**AMENDMENTS TO BOOKLETS 90 AND 92
(S4082 Tape Reader Units)**

Note: The following amendments apply to Model 90, 5-Wire Keyboard Tape Verifier, and Model 92, 5-Wire Tape Reader, when fitted with S.4082 Tape Reader Unit.

This T.I.S. cancels T.I.S. 61 (December, 1957).

T.I.S. No. 72

FIG. 1a .

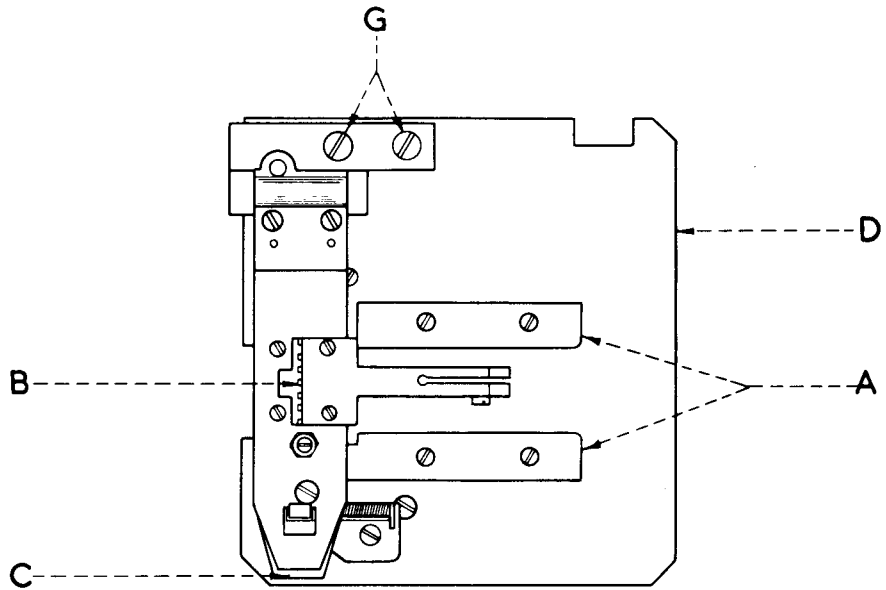
On page 1 of Booklet 92 and page 5 of Booklet 90, delete Adjustment 1 and insert the following new adjustment:-

"1. Tape Retaining Plate (Figs. 1A and 2A)

- 1.1 With the tape retaining plate C closed, check that the tips of the reading levers are in the same vertical plane as the centre line of the tape roller B, and that they are positioned centrally with respect to the corresponding slots in the roller.

- 1.2 Adjust, if necessary, by slackening screws G and moving the retaining plate C until the correct position is obtained. Tighten screws G.

FIG. 2a

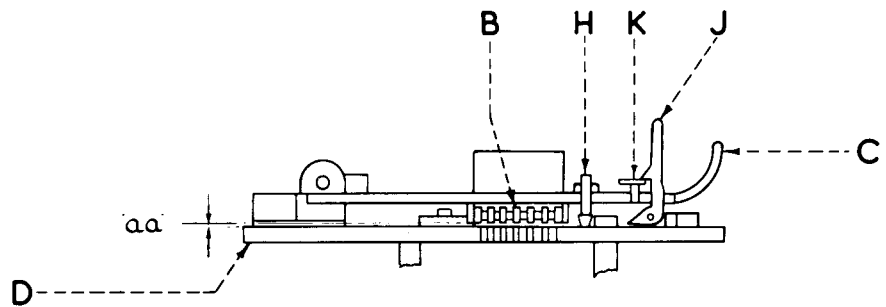
- 1.3 Place a screwdriver between the main plate and the reading levers so that the latter are held down below the surface of cover plate D. With the levers thus held clear, and with the tape retaining plate C closed, check that tape roller B clears cover plate D by .007 - .009 in. (.18 - .23 mm.), i.e. dimension 'aa', Fig. 2A.

1.4 To adjust, slacken the locknut of stop screw H and turn the latter until dimension 'aa' is set up. Clamp stop screw H with its locknut.

FIG. 4a

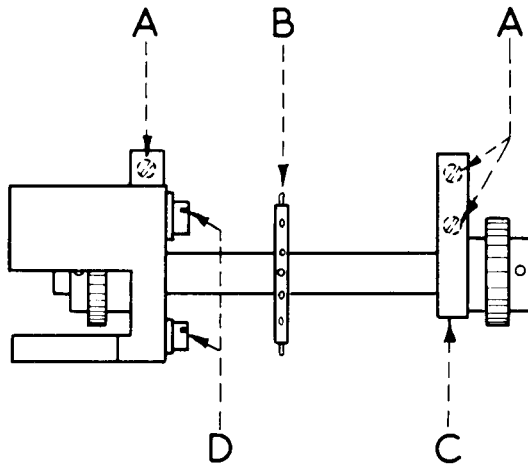
2.2 If necessary, slacken screws A, Fig. 4A, and adjust the position of the bearing blocks C to satisfy this condition. Tighten screws A."

4.3 If either of these conditions is not satisfied, slacken screws A, Fig. 4A, until bearing blocks C are friction tight and reposition the blocks until both requirements are met. Tighten screws A and recheck adjustment 2."

FIG. 12

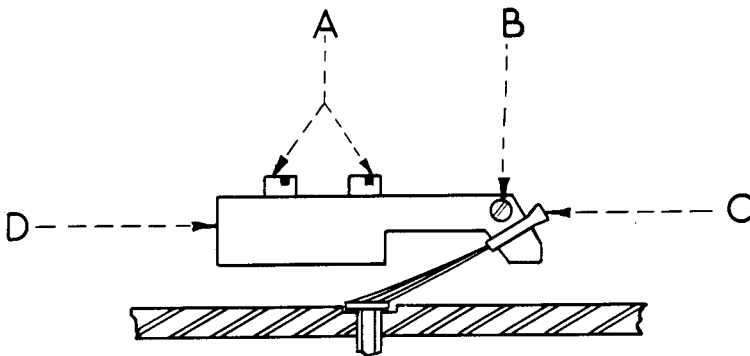
"18. Feed Alarm Brush (Fig. 12) (when fitted)

18.1 With perforated tape in the machine, check that the tip of brush C, Fig.12, lies centrally in the tape feed hole.

18.2 If this is not so, slacken screws A until block D is friction tight and adjust the block to satisfy this condition. Tighten screws A.

18.3 Check that the brush tip is deflected $\frac{1}{16}$ in. (1.6 mm.) when the tape gate is closed.

18.4 If necessary, slacken screw B and re-position the brush in block D to give the required deflection. Re-check adjustment 18.1."
